KEENE PLANNING BOARD
Council Chambers, Keene City Hall
May 26, 2026
6:30 PM

1. **PB-26-10 - Habitat for Humanity Duplex, Cottage Court Conditional Use Permit** — Applicant SVE Associates, on behalf of owner Monadnock Habitat for Humanity, proposes to construct a 1,364 sq-ft duplex at the property located at 0 Grove St. (TMP# 585-057-000). The parcel is ~.11 ac and is located in the Residential Preservation District.

Meeting Date: May 26, 2026
To: Planning Board
From: Mari Brunner, Senior Planner
Through: Paul Andrus, Community Development Director
Subject: **Applications Ready for Final Approval**

SITE PLAN

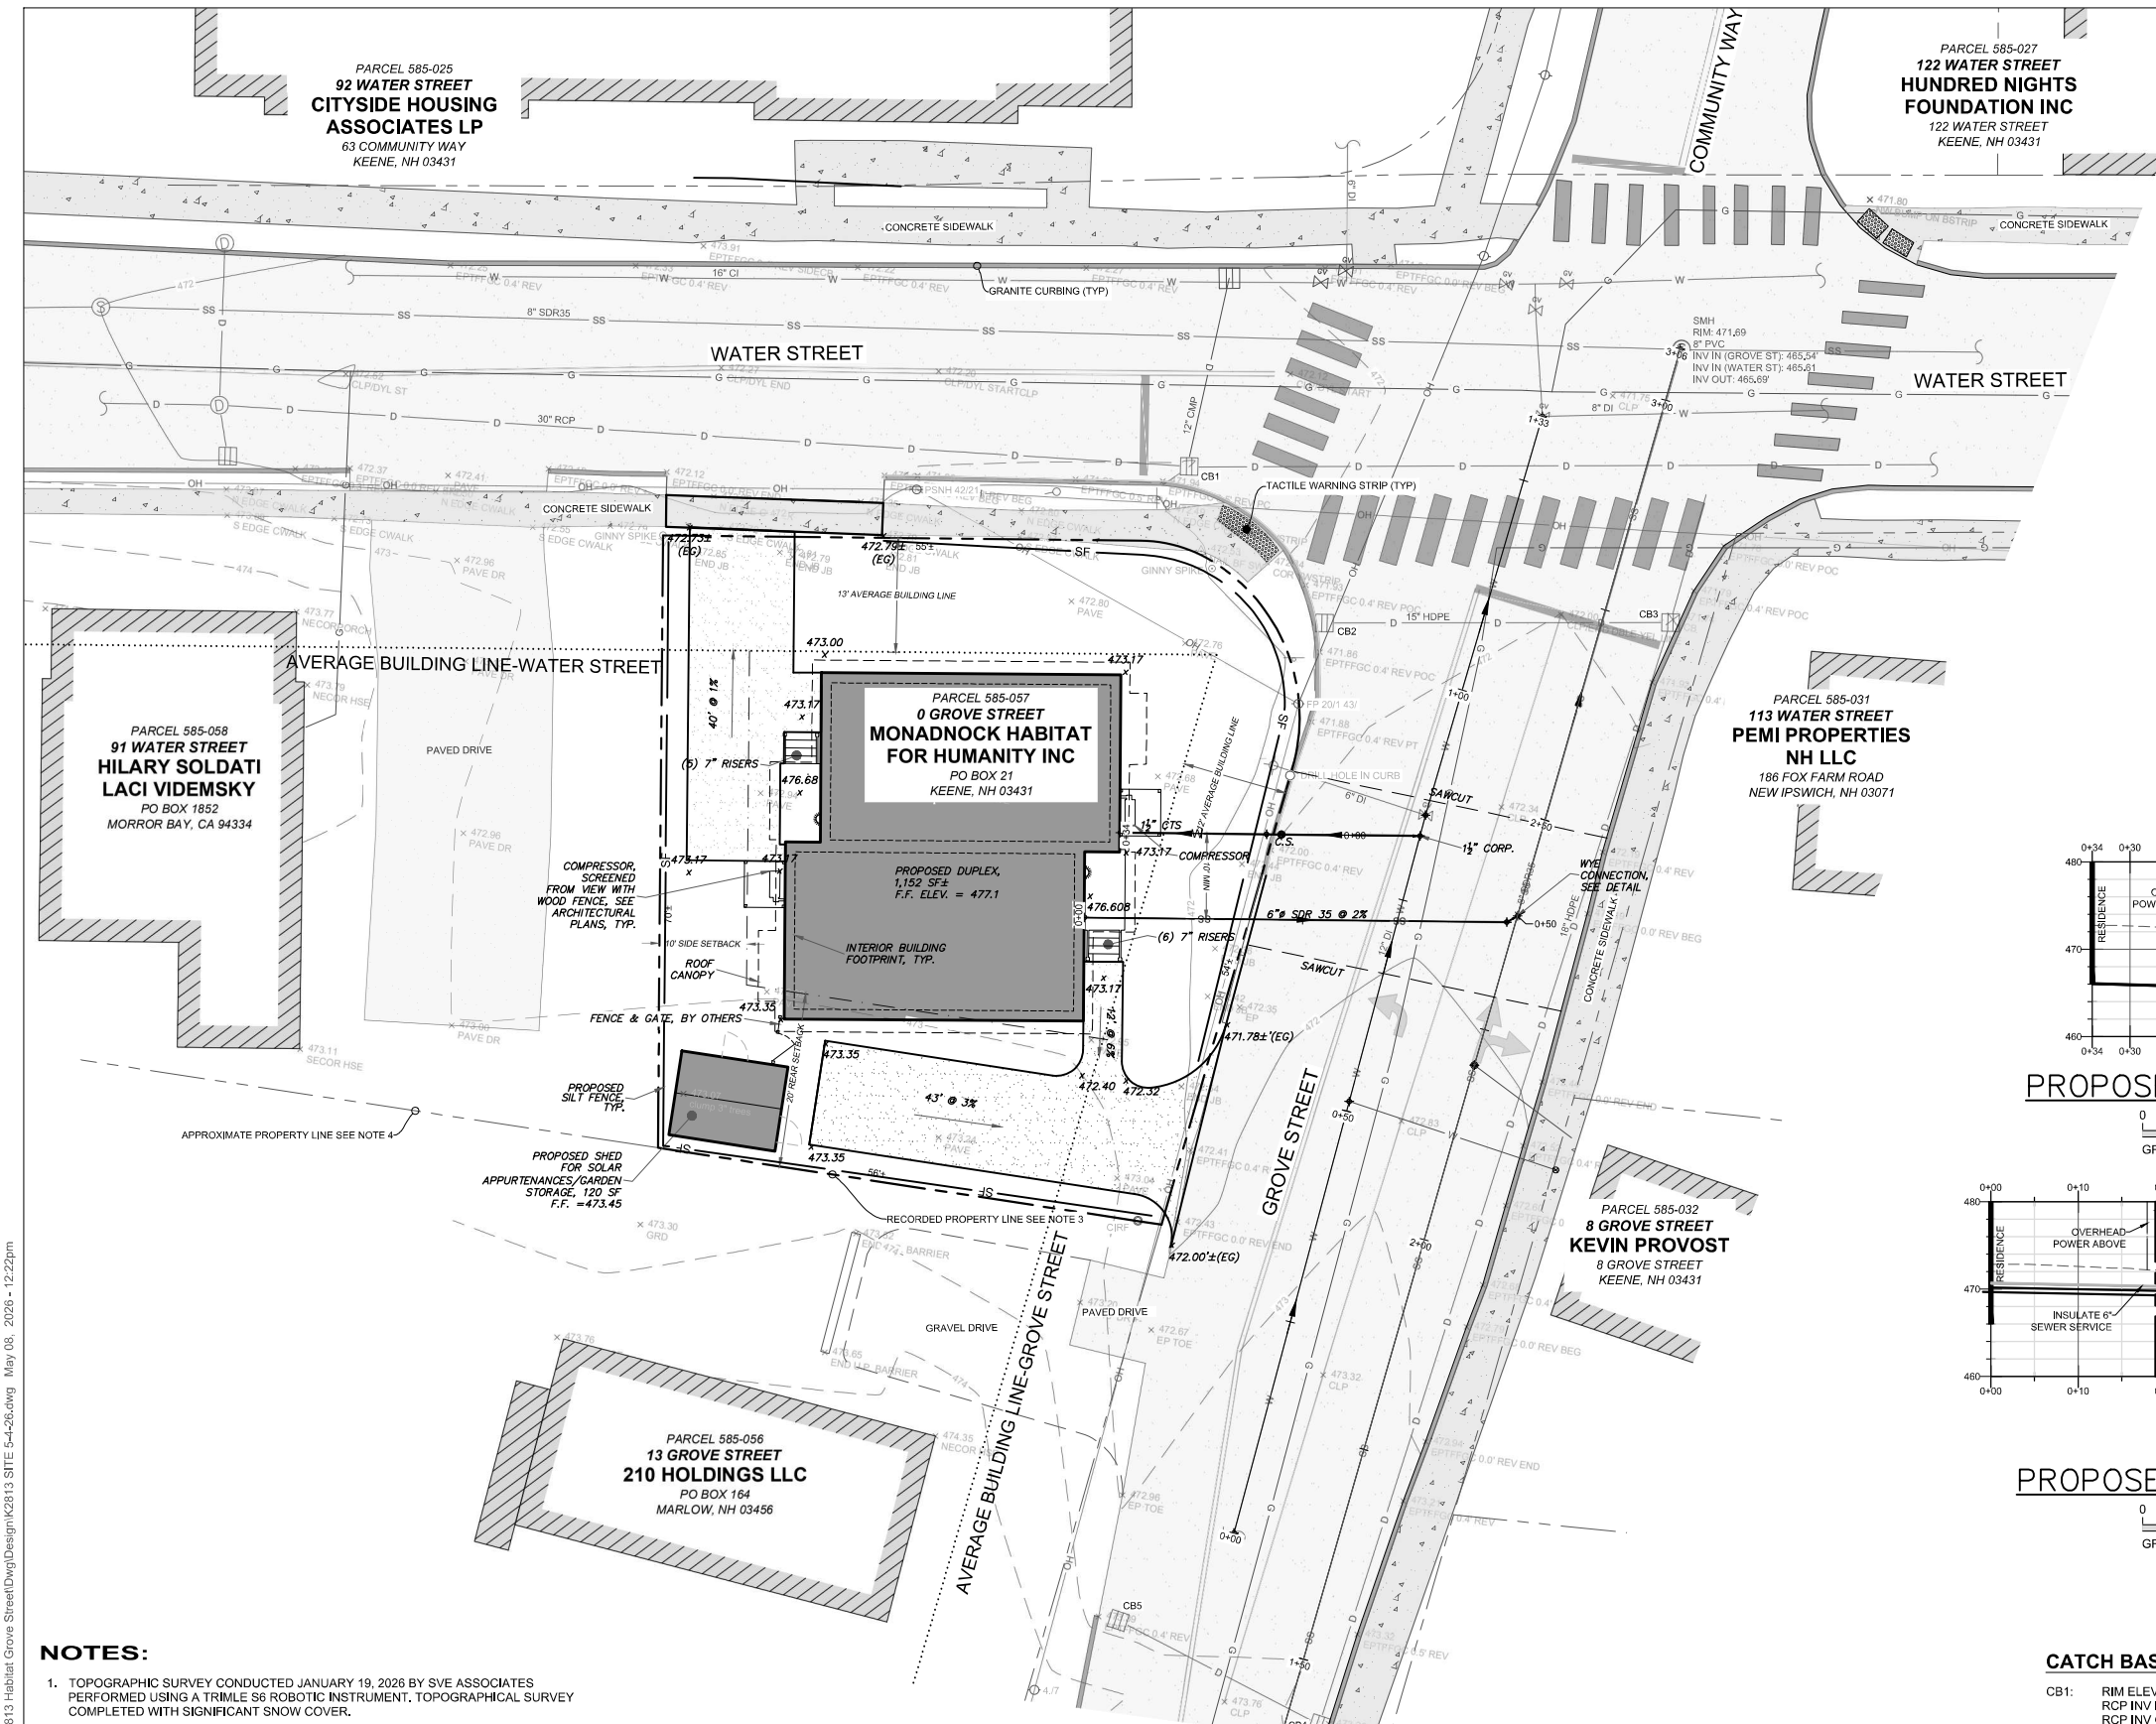
- The plans show the proposed water service curb stop on private property in profile view; this must be revised to show the curb stop in the Grove Street ROW.
